STATE OF NORTH CAROLINA
DEPARTMENT OF TRANSPORTATION

September 30, 2025

SUBJECT: Request for Modification of the Phased Section 404 Individual Permit and Section 401 Individual Water Quality Certification for the construction of the Triangle Expressway Southeast Extension from NC-55 Bypass in Apex to I-40, Wake and Johnston Counties. TIP Nos.: R-2721, R-2828, and R-2829. Federal Aid Project No. 0540047.

We are requesting a modification to Section 404 Authorization (SAW-2019-02240) and the associated 401 Individual Water Quality Certification (Permit No. 20181249). This request is prompted by several areas changing from one wetland impact type to another (e.g. mechanized clearing to excavation) or temporary stream impacts changing to permanent stream impacts for bank stabilization purposes. Also, additional impacts are needed for a ditch tie-in at Wetland WHG, which was removed during the 4B meeting, but is being added back in as a permit site (Site 13). Details of why these changes are being made are provided below.

PERMIT DRAWING
SHEET 83 OF 112

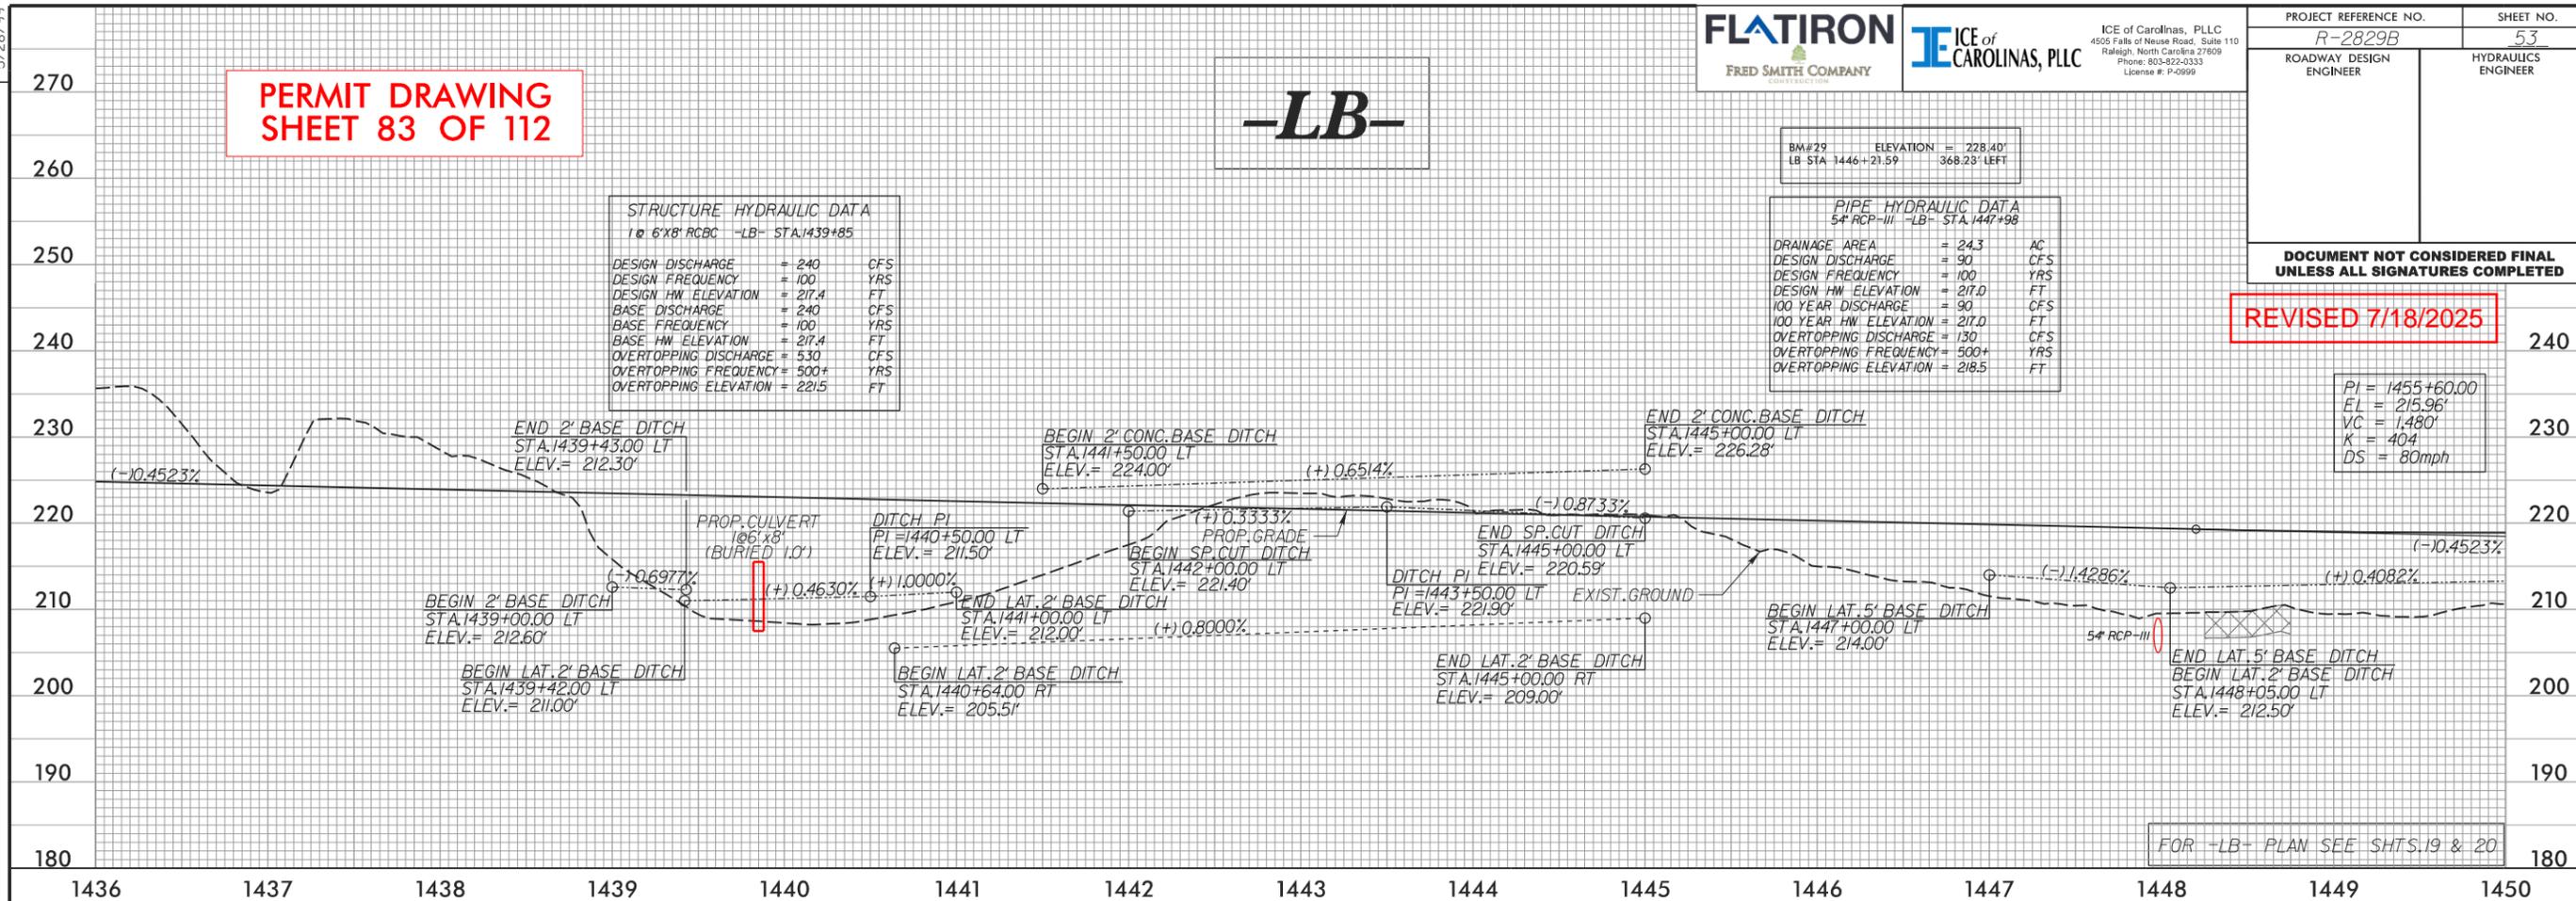
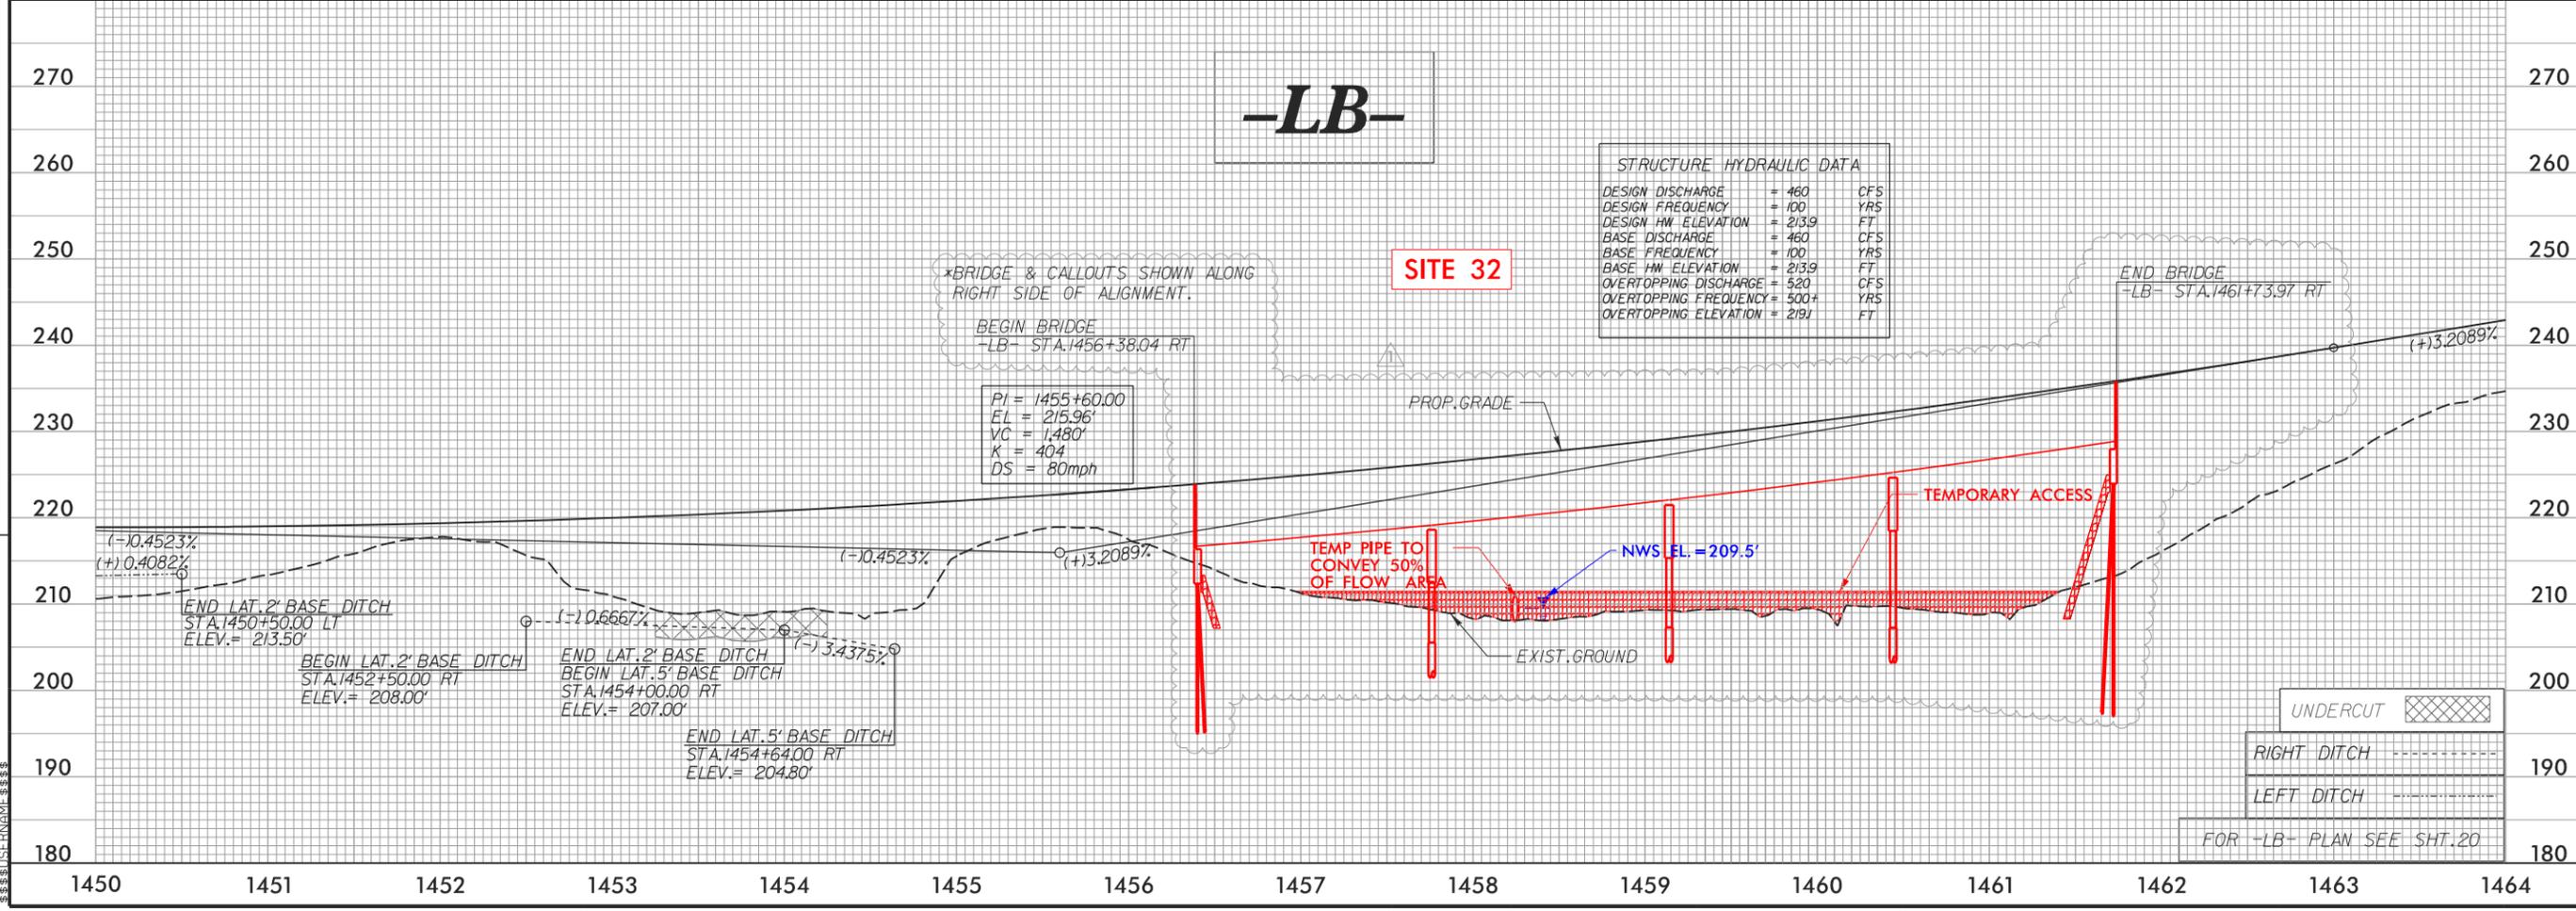
REVISIONS
5/28/99
5/2/2025: UPDATED BRIDGE STATION CALLOUTS TO MATCH FINAL BRIDGE PLANS.
